SUNDRY NOTICES AND REPORTS ON WELLS

8. Well Name and No.  
"P" 17

Re: Permanent Abandonment

Well: **17 Navajo P**

Navajo "P-17"

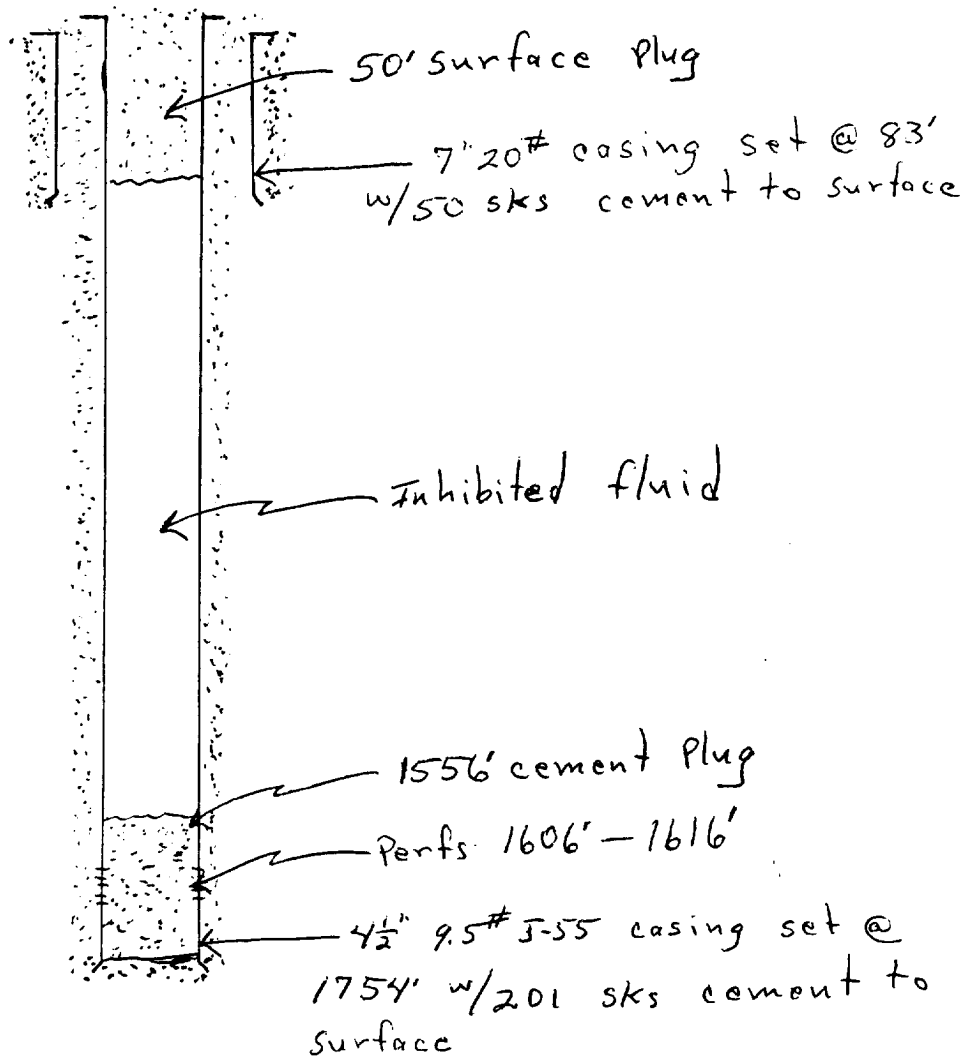
Plan to Plug well as follows:

1. equalize cement plug from 1754' to 1556'
2. pick up to 1555' circulate inhibited fluid to 50'
3. Circulate Cement from 50' to surface
4. weld on dry hole marker, clean and remediate location.

3. The following modifications to your plugging program are to be made (when applicable):

1. **Tag top of cement plug @ 1556'.**

2. Spot a cement plug from 1321' to 1221' inside the casing plus 50 linear feet excess. (top of Gallup @ 1271')

3. Extend surface plug from 208' to the surface on the inside of the casing. (surface casing @ 83' and the bottom of the Point Lookout @ 158')
